**Re: Supplemental Appeal Justification Letter; 1114 North Heliotrope Drive;
Case nos. DIR-2021-1238-TOC-SPP-HCA-1A; ENV-2021-1239-CE
Council File no. 24-1083**

This firm represents Linoleum City, Inc. ("Appellant") with regard to the appeal of environmental clearances issued by the City of Los Angeles ("City") for the proposed development project located at 1114 North Heliotrope Drive. This letter supplements Appellant's justifications for appeal and addresses the inadequacy of the expert reports prepared for the Project.

We have reviewed Air Quality, Greenhouse Gas and Noise studies prepared by Yorke Engineering on behalf of the Applicant for the 1114 N. Heliotrope Drive and 1115 N. Berendo Street projects and provide here our comments on the noise sections.

Figure 3
Source Location

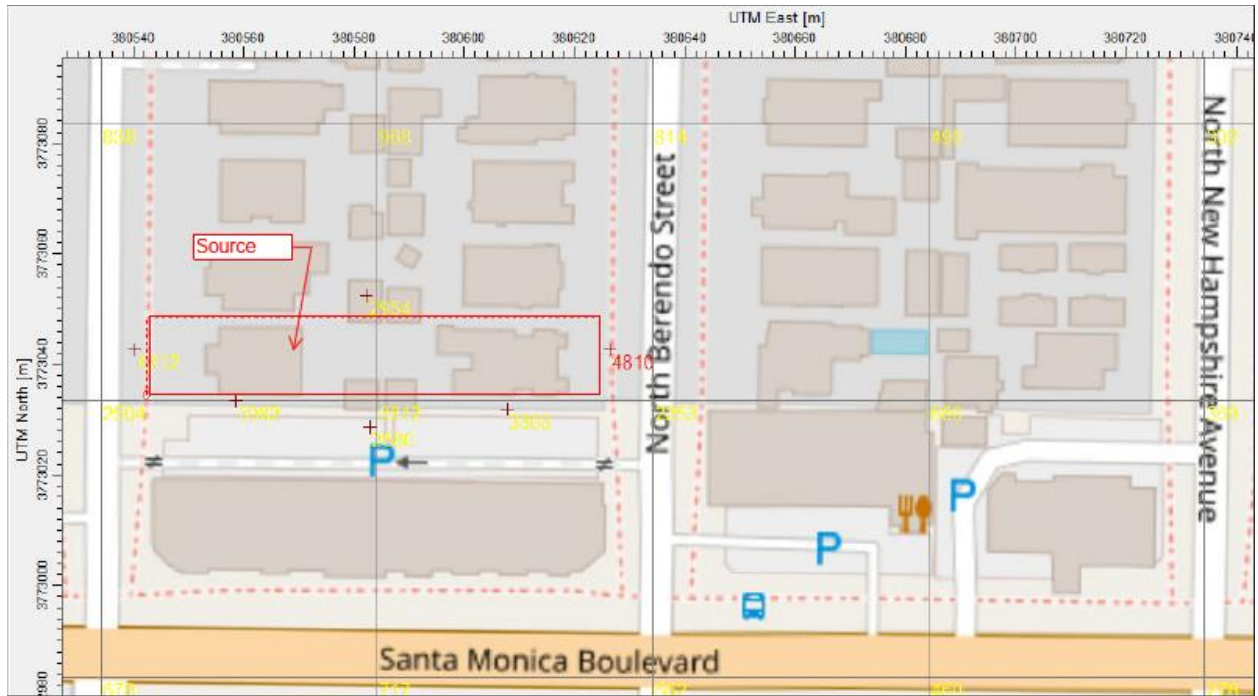
Emissions were modeled as a single rectangular area source 1,155 square meters (Figure 3). An emission release height of 5 feet was assumed.

Spatial Distribution of 1-Hour NO_x Concentration

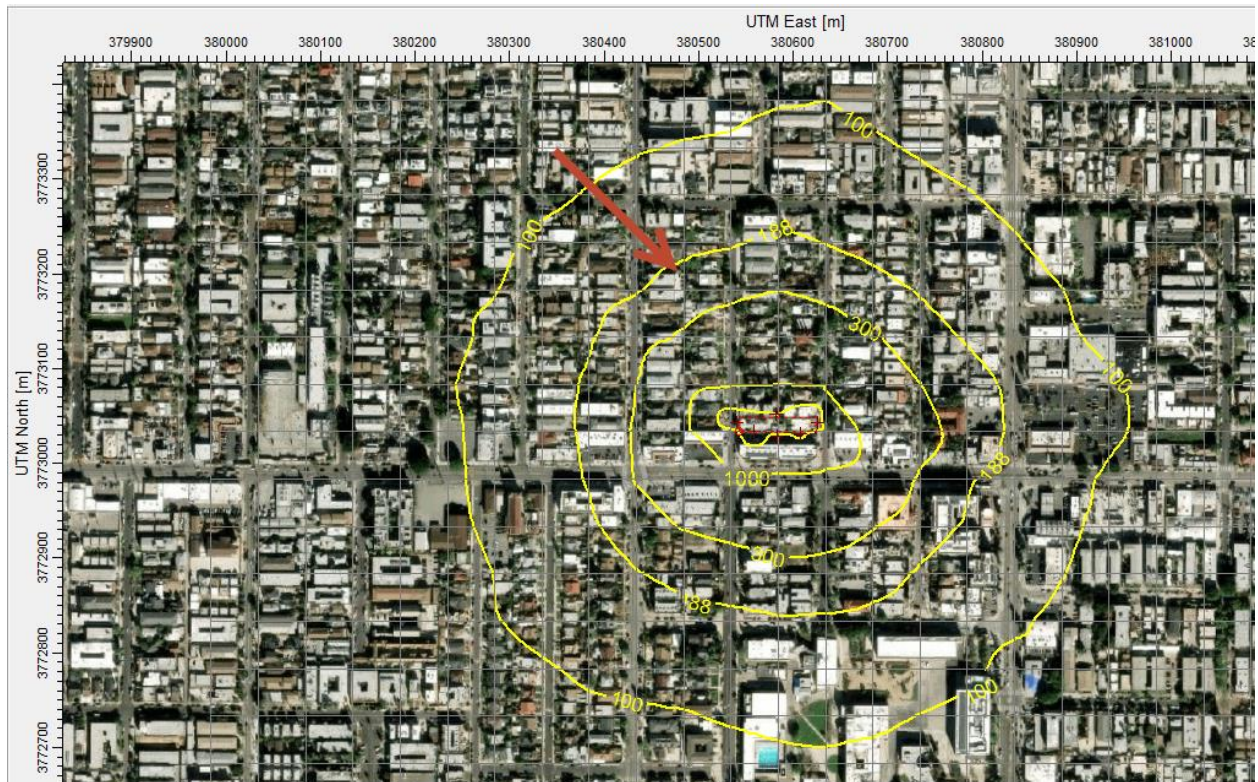
The spatial distribution of NO_x is provided in Figures 3 and 4. The area within the contour marked “188” in Figure 3 would exceed the federal 1-hour NO_x standard. These results indicate that the construction phase of this project would lead to significant NO_x related air quality impacts, which have not been disclosed in the air quality reports prepared by Yorke.

Note: Area inside the contour labeled "188" exceeds the federal 1-hour NO_x standard
